APPLICATION NO.	FILING DATE	FIRST NAMED INVENTOR	ATTORNEY DOCKET NO.	CONFIRMATION NO.
09/583,583	10/23/2000	Mathieu Vandebossche	1200-370	2518
7590 12/16/2004				
Matthew W Stavish Liniak Berenato Longacre & White 6550 Rock Spring Drive Suite 240 Bethesda, MD 20817			EXAMINER AGUIRRECHEA, JAYDI A	
			ART UNIT 2834	PAPER NUMBER
DATE MAILED: 12/16/2004

<b>Office Action Summary</b>	<b>Application No.</b>		<b>Applicant(s)</b>	
	09/583,583		VANDENBOSSCHE, MATHIEU	
	<b>Examiner</b>		<b>Art Unit</b>	
	Jaydi A. Aguirrechea		2834

## **DETAILED ACTION**

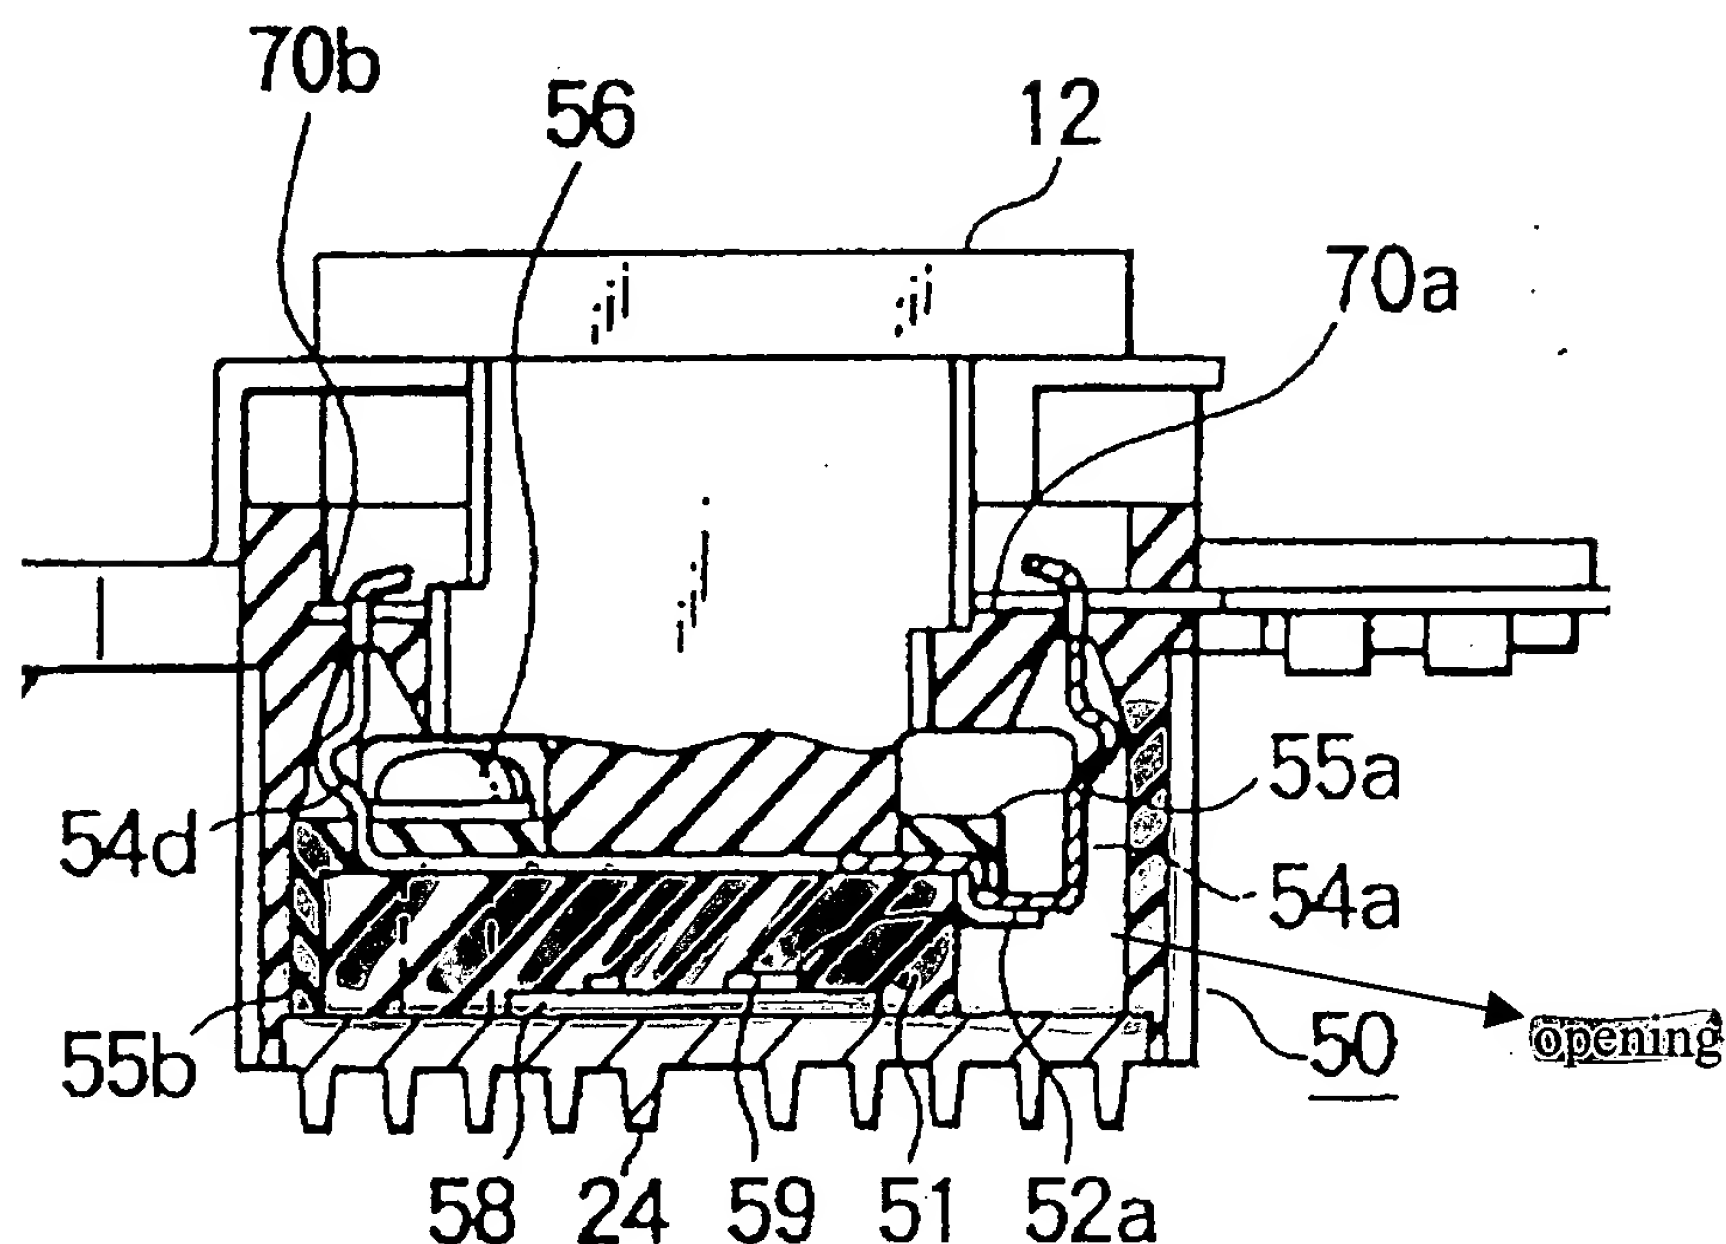
Referring to claim 1, Komurasaki et al. disclose a brush holder (12) for a vehicle alternator having a housing (2), the brush holder (12) comprising: an insulating support (51) having an opening (see figure below), heat dissipating means (24,58) having a metallic seat (58) fixed to the support (51); and an electrical circuit (59) comprising: a semiconductor control component, in which the seat (58) on the one hand receives for fixing on one of its faces the control component (51) by means of an opening in the support (see figure below) and on the other hand belongs to the heat dissipation means (24,58) in contact with an ambient environment and arranged so as to receive heat from the control component (59), wherein the seat (58) is separate from the housing (2) and not in contact with the housing (2), the seat (58) is mounted within a thickness of the support (51) and the seat (58) receives on the other of its faces a heat

dissipator (24) so that the heat dissipation means (24,28) is composed of two distinct and adjacent parts (Figure 1).

7. Applicants argument that the opening is for the passage of the screw is not persuasive. As shown in the figure above (Fig. 1 in Komurasaki) there is an opening were the control component is fixed to the seat.
